## Memorandum

Subject: Public Testimony for West Linn Planning Commission Public Meeting  
SUB-17-04

On December 8, 2017 Staff received a letter addressed to all those who attended the neighborhood meeting for the proposed subdivision at 4096 Cornwall Street (SUB-17-04) from the applicant. This letter clarified some major changes between SUB-17-01 and SUB-17-04 and thanked the participants for attending. Two attachments to the letter included a color map of the proposal and the proposed layout of the subdivision.

Photo #4– Picture taken May 17. 2017

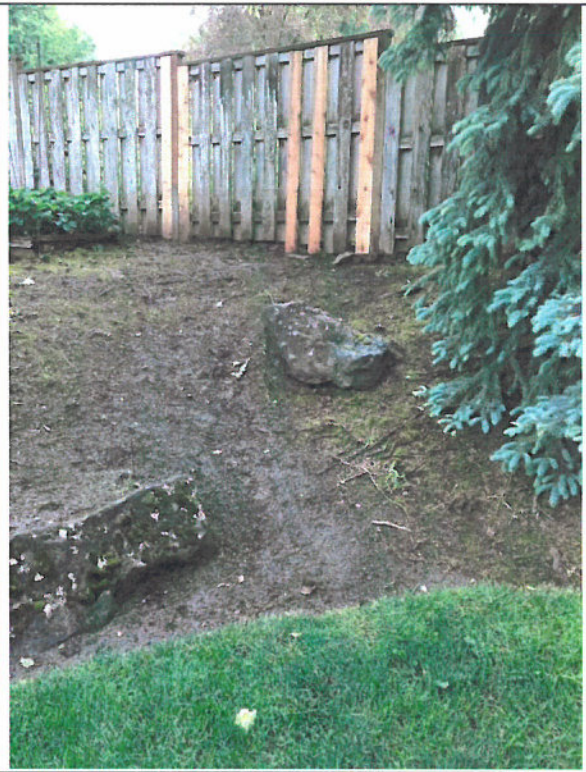
3775 Fairhaven Drive, South side back yard erosion from surface water flow.
